# Return loss and impedance

# Some issues related to return loss and impedance

# Detail: comment 52, KRn transmitter differential output return loss

# For info: P802.3bs D3.3 comment 34 (C2C receiver differential input return loss)

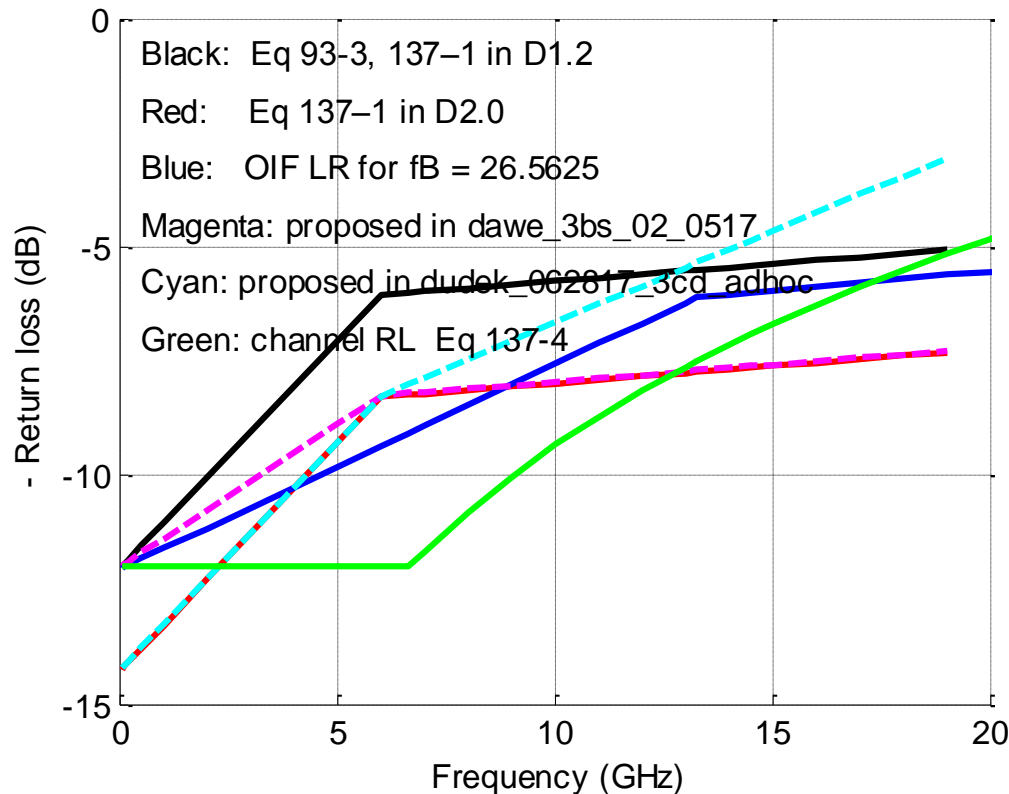
- Changing the return loss spec for the receiver was a mistake, because the effects of receiver reflections to a nominal-impedance channel and transmitter are in the receiver interference tolerance test, and the extra reflections to a channel and transmitter with different impedances are controlled/accounted for by the channel COM, now based on nominal impedances, the new channel return loss spec and the transmitter return loss spec.
- From the simple formula for reflection at an impedance mismatch, one can see that these effects are close to additive, so controlling/accounting for them separately is OK. In other words, the receiver pays for its own reflections in the interference tolerance test, so **we don't have to tell the receiver designer how to do his job** in this regard.
- **In Table 120D–5, revert 120D.3.1.1, Equation (120D-2) to 93.8.1.4, Equation (93-3).**

# Focus on Tx, Rx RL

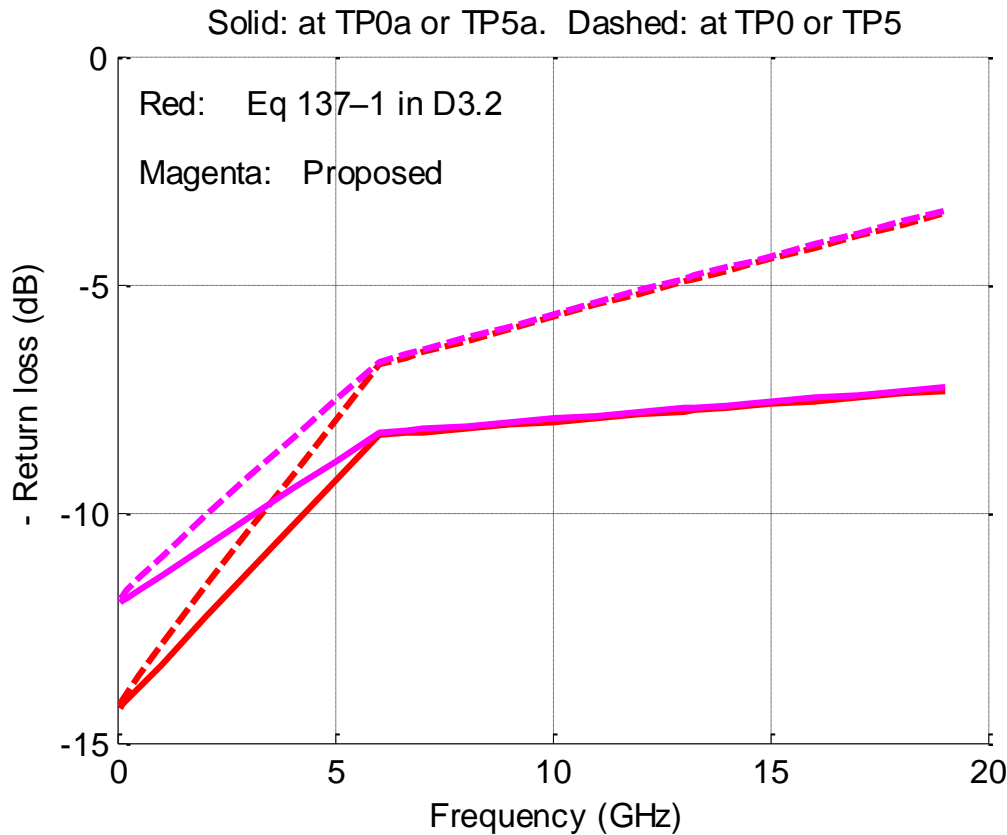
- Red is too tight at low f

# Adjusting for test fixture IL but not its RL

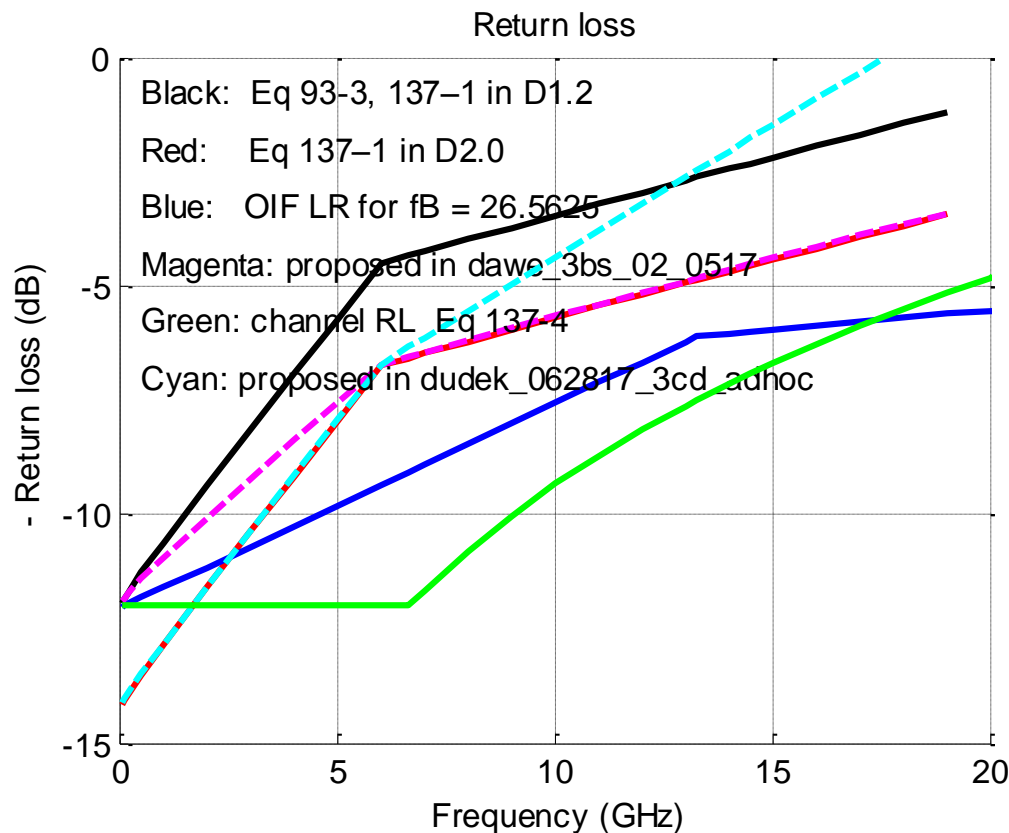
- Compare previous slide
- Red and cyan are too tight at low  $f$
- Cyan is too loose at high  $f$
- Black is too loose at mid  $f$
- Green – channel

# The echo, which is what matters, is caused by two reflections

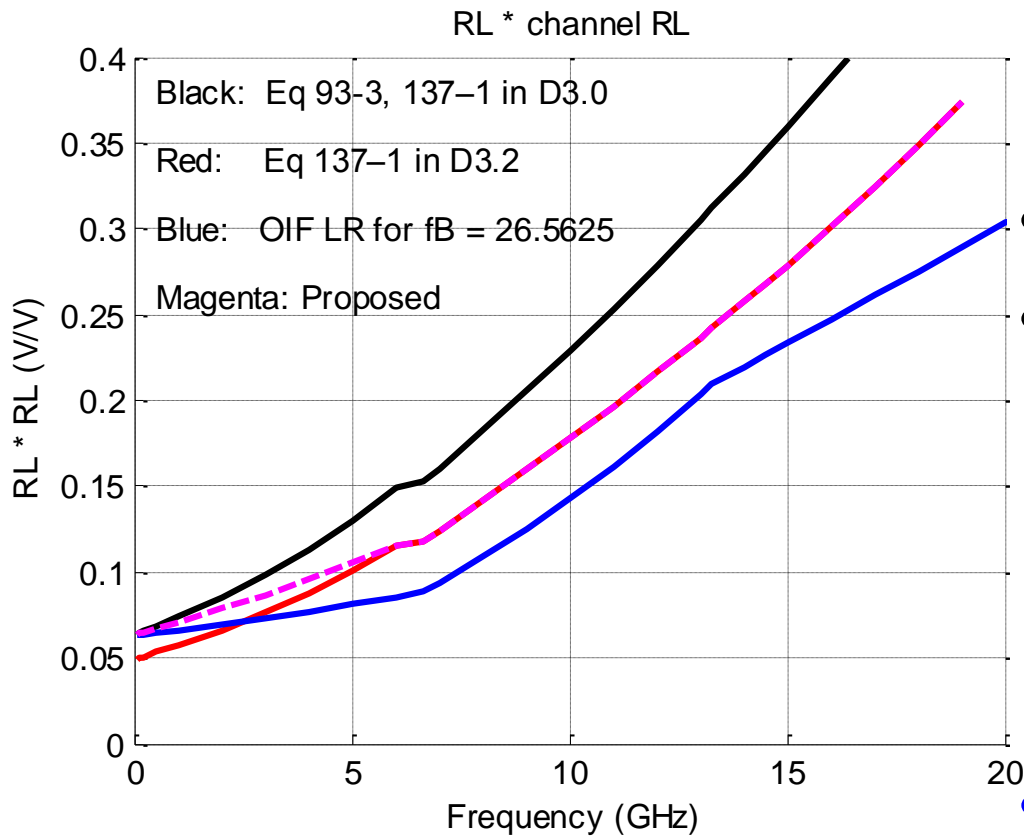
- Multiplying (Tx or Rx) reflection by channel reflection
- Voltage scale is different
- Receiver boosts high frequencies
  - and attenuates beyond Nyquist
  - making the gradients steeper
- The low frequency content is insignificant

# Summary so far

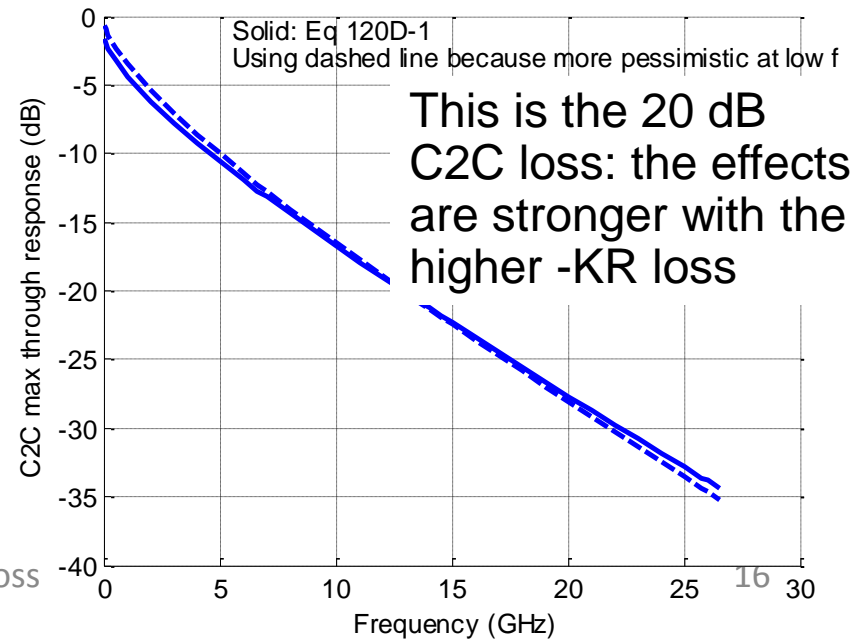
- The low frequency reflections between Tx and channel or Rx and channel are negligible – higher frequency reflections dominate
- Reflections between Rx and nominal channel are in RITT anyway – only some of the Rx-channel reflection needs to be bounded by the RL specs, the other part is in the test
- But, what about end-to-end reflections?

# The echo, which is what matters, is caused by two reflections

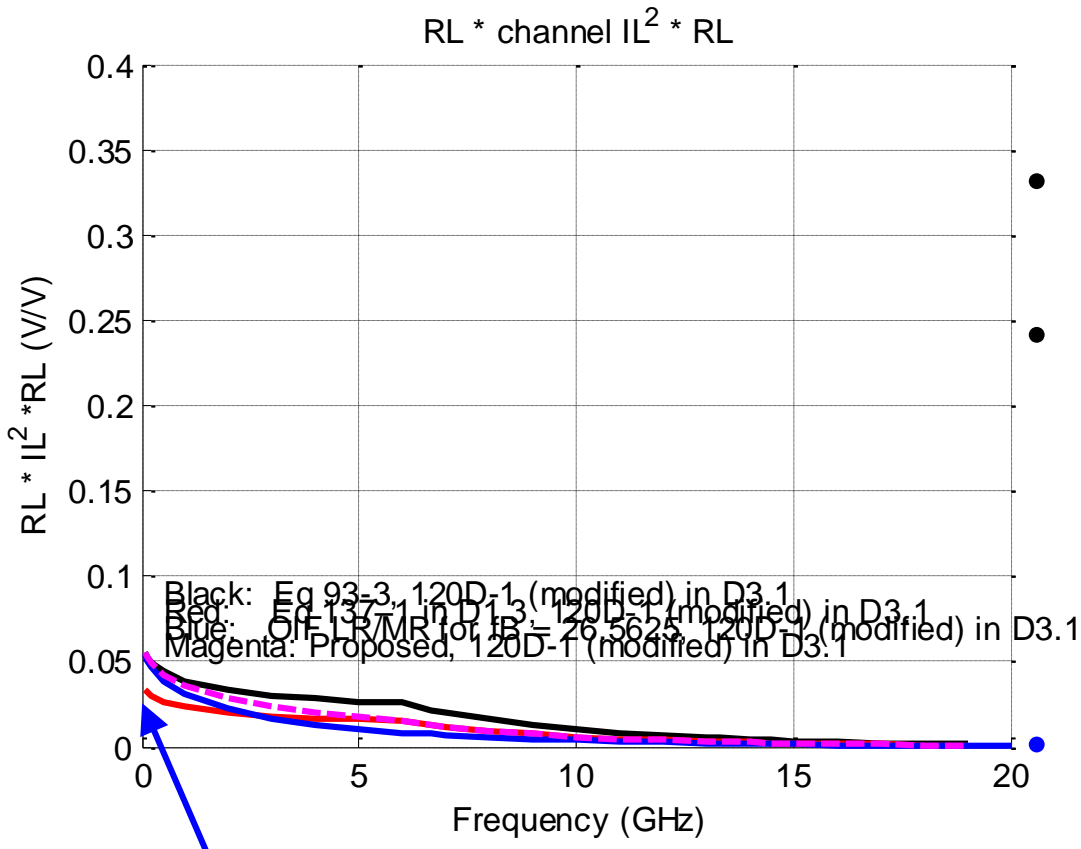
- Multiplying (Tx or Rx) reflection by channel through response squared
- Same voltage scale as two slides before
- Receiver boosts high frequencies
  - and attenuates beyond Nyquist
  - but the lines will still slope downwards

In practice, this peak will be several dB lower – see example channel RLs in last slide

• For high loss channels, the end-to-end reflections are much smaller than the end-channel reflections

# Channel return loss replotted on log f scale

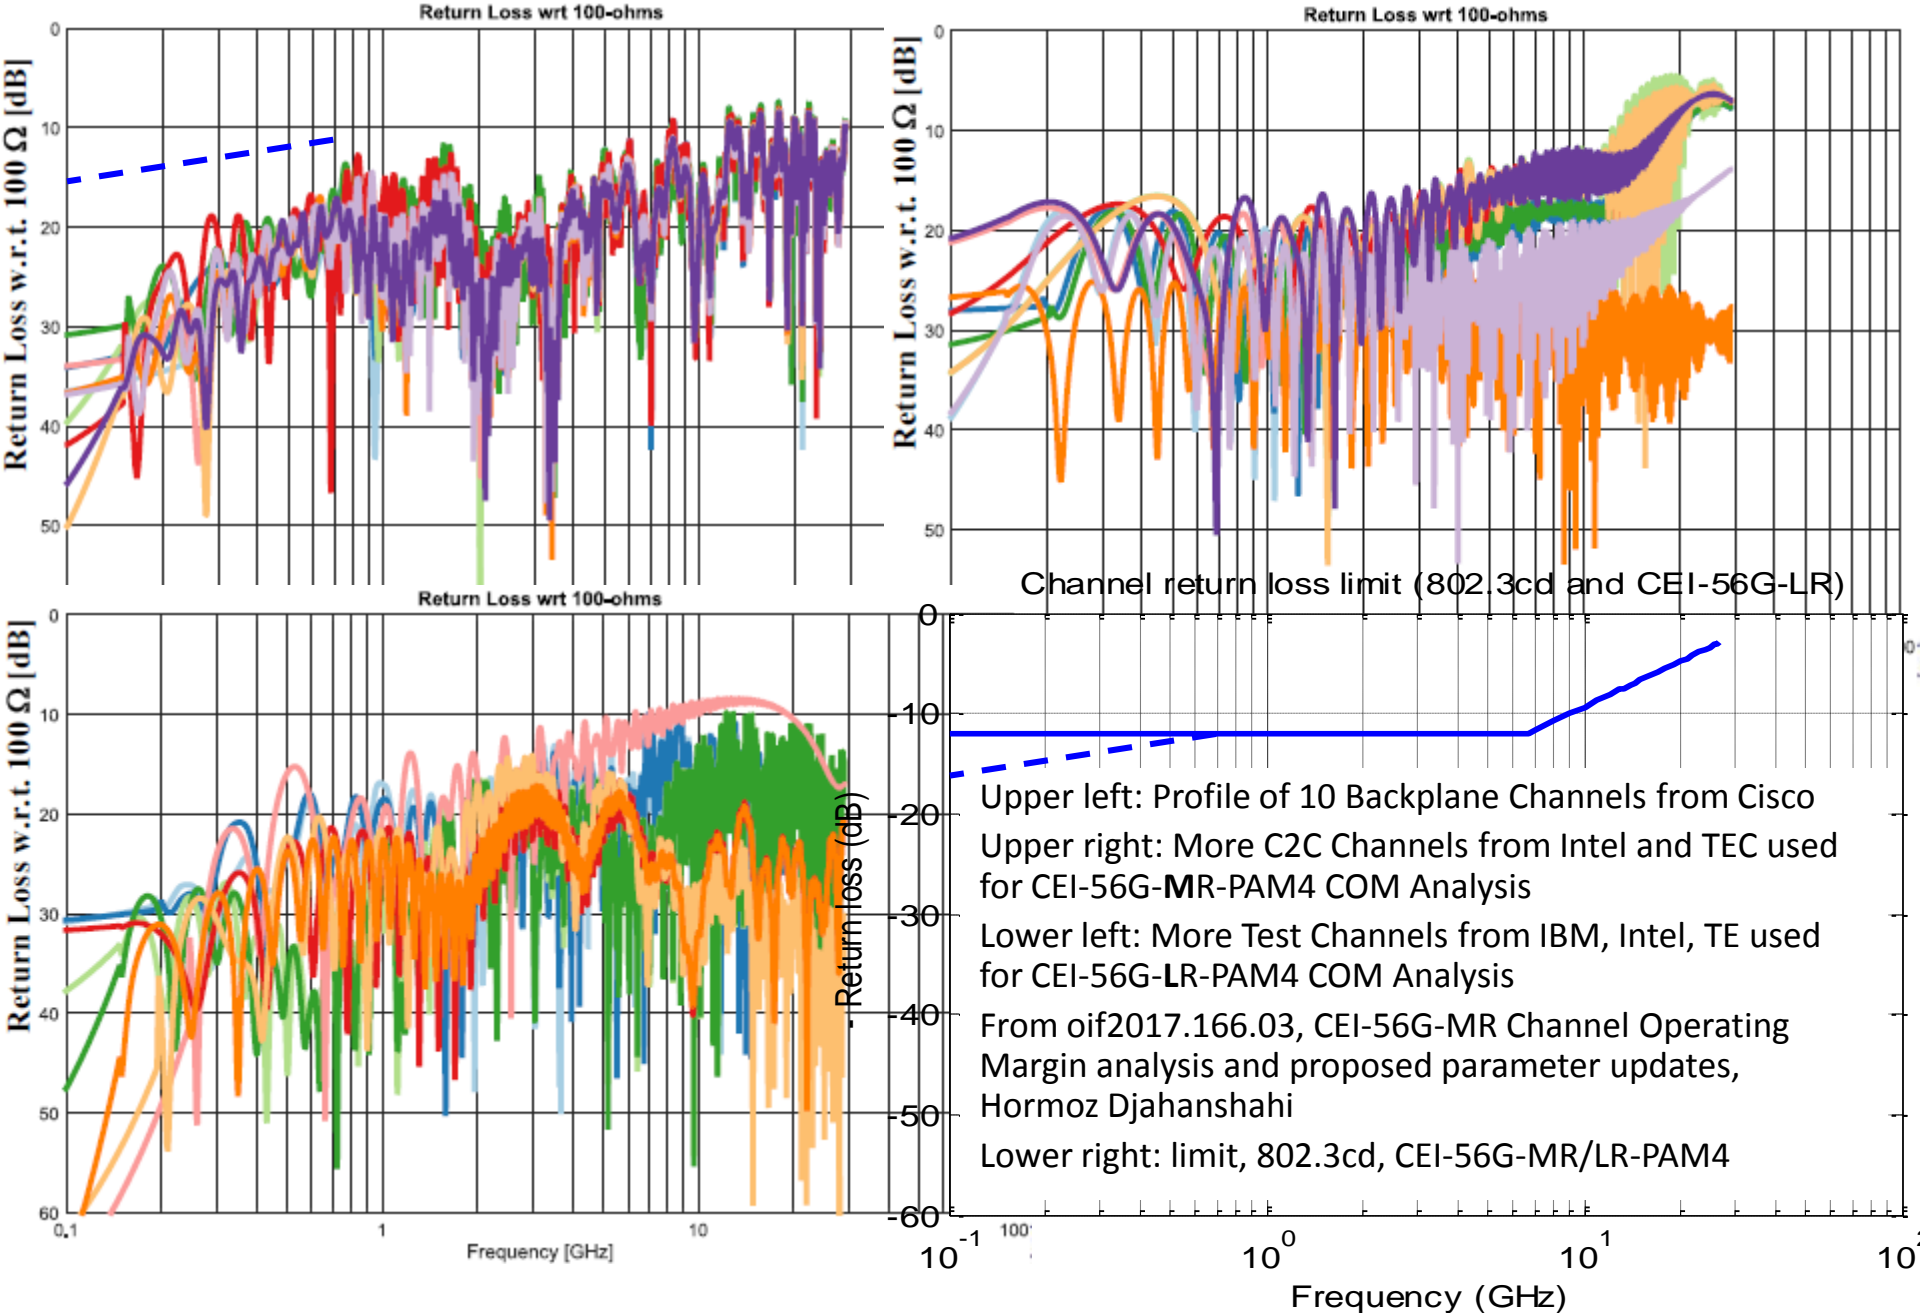
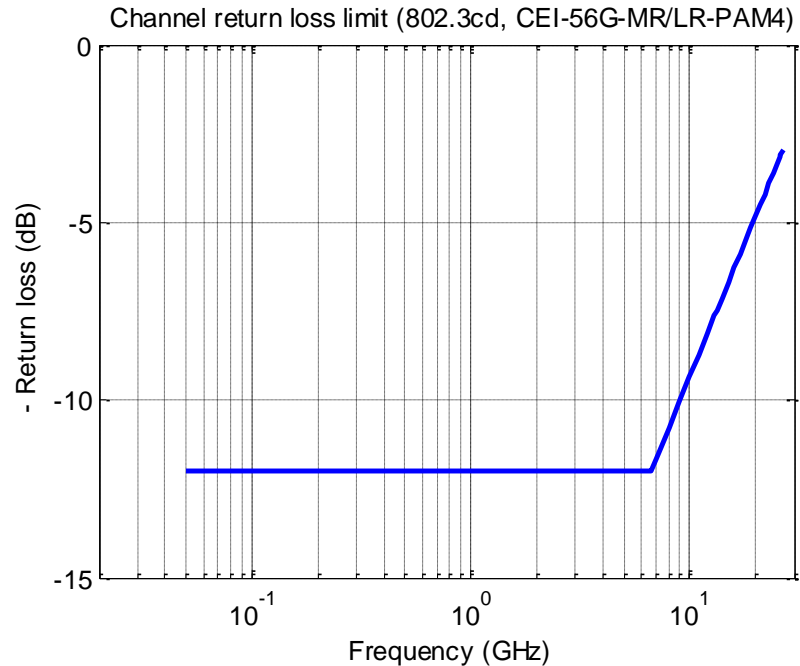
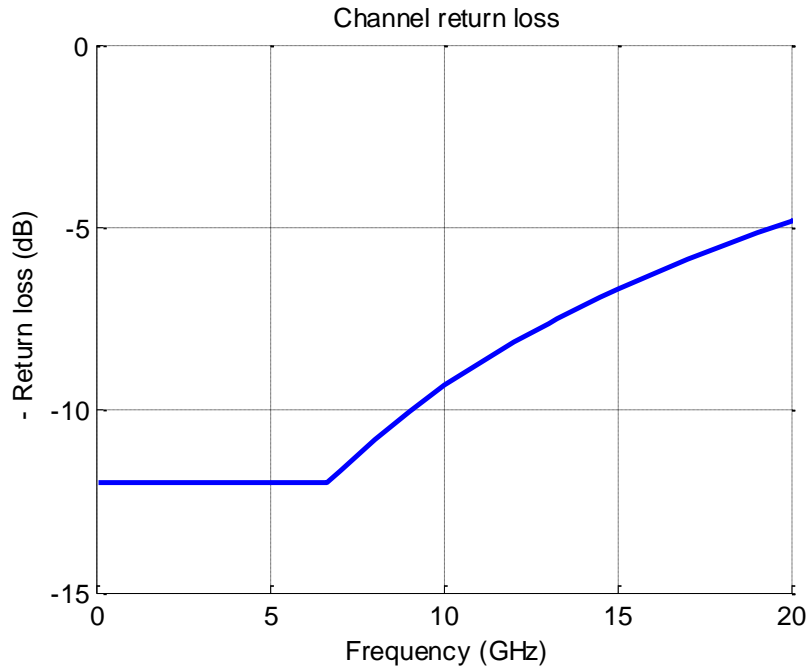
- Channel return loss (at TP0 or TP5) from 802.3bs Eq. 120D-12, 802.3cd Eq. 137-4
- Also OIF CEI-56G-MR-PAM4 Eq 17-3 and LR-PAM4 Eq 21-3

*It appears that channel RL will be much better than spec < 1 GHz*
